PUBLIC INTEREST REVIEW FOR GROUND WATER APPLICATIONS

SUBJECT: Application G- 17619 Supersedes review of _____
Date of Review(s)

A. GENERAL INFORMATION: Applicant's Name: Robert and Justin Ditchen County: Marion

- A1. Applicant(s) seek(s) 0.445 cfs from one well(s) in the Willamette Basin,
Pudding subbasin Quad Map: Salem East
- A2. Proposed use: Irrigation, 25.0 acres Seasonality: April 1 to October 1
- A3. Well and aquifer data (attach and number logs for existing wells; mark proposed wells as such under logid):

Oregon Water Resources Department hydrograph for MARI 6564 (7.00S / 2.00W - 4BDA)

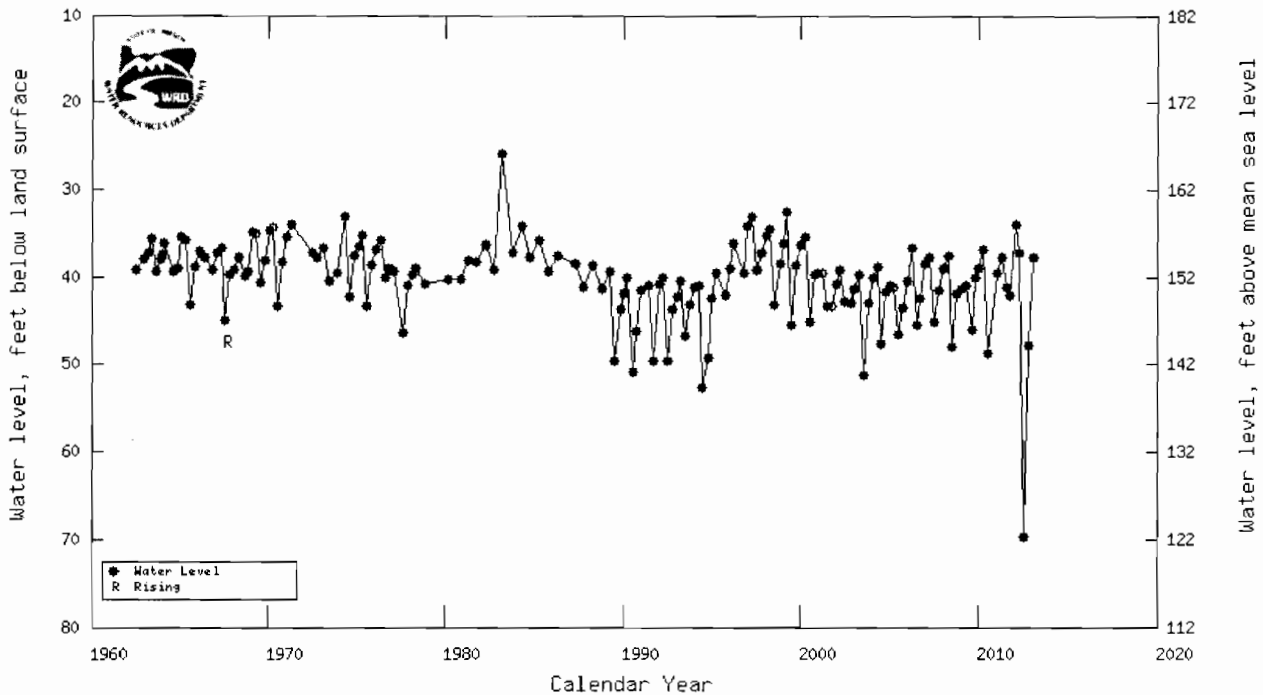
B3. **Ground water availability remarks:** Nearby State Observation Well MARI 6564 is displaying relatively stable water levels.
